MEC170x Silicon Errata and Data Sheet Clarification

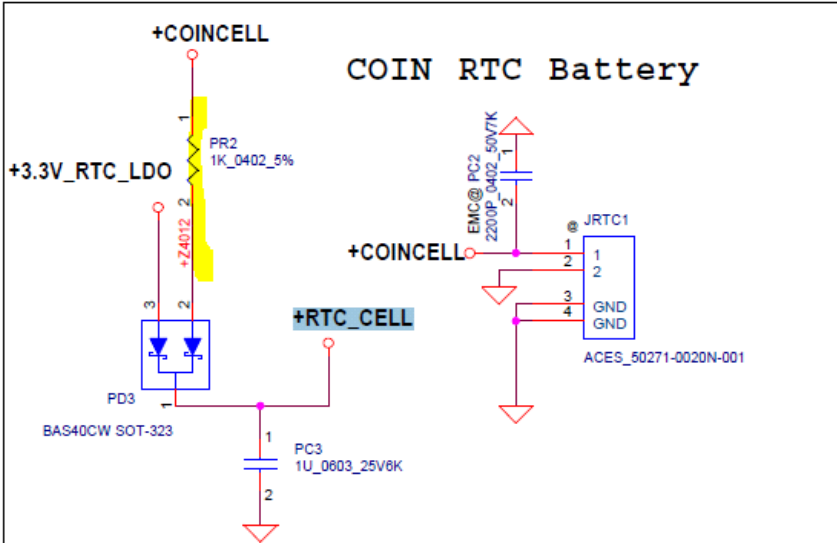
There could be a high I_{BAT} current on new coin cell insertion. During initial VBAT power rising, the VBAT circuit can enter a high current state causing a voltage drop across the 1K UL resistor. This affects all 128 and 144 pin packages. This issue is not present in the 169 pin packages.

- Under these conditions, the VBAT power on can stall in this high current state, with the VBAT on device pin between 0.7 and 1.2V.

Insert the coin cell and then apply VTR (i.e +3VALW). This enables VBAT low-power operation. A high I_{BAT} will not return on subsequent VTR power cycles.

Referring to the RTC Battery circuit shown in [Figure 1](#), applying VTR via the +3.3V_RTC_LDO signal, powers RTC_Cell (which is connected to VBAT of MEC5105/6) directly (without a series 1k resistor and hence no IR drop from the applied VTR), raising VBAT (RTC_Cell) to greater than 2.0 volts. This takes VBAT out of the "high current" region discussed above enabling normal VBAT low power operation.
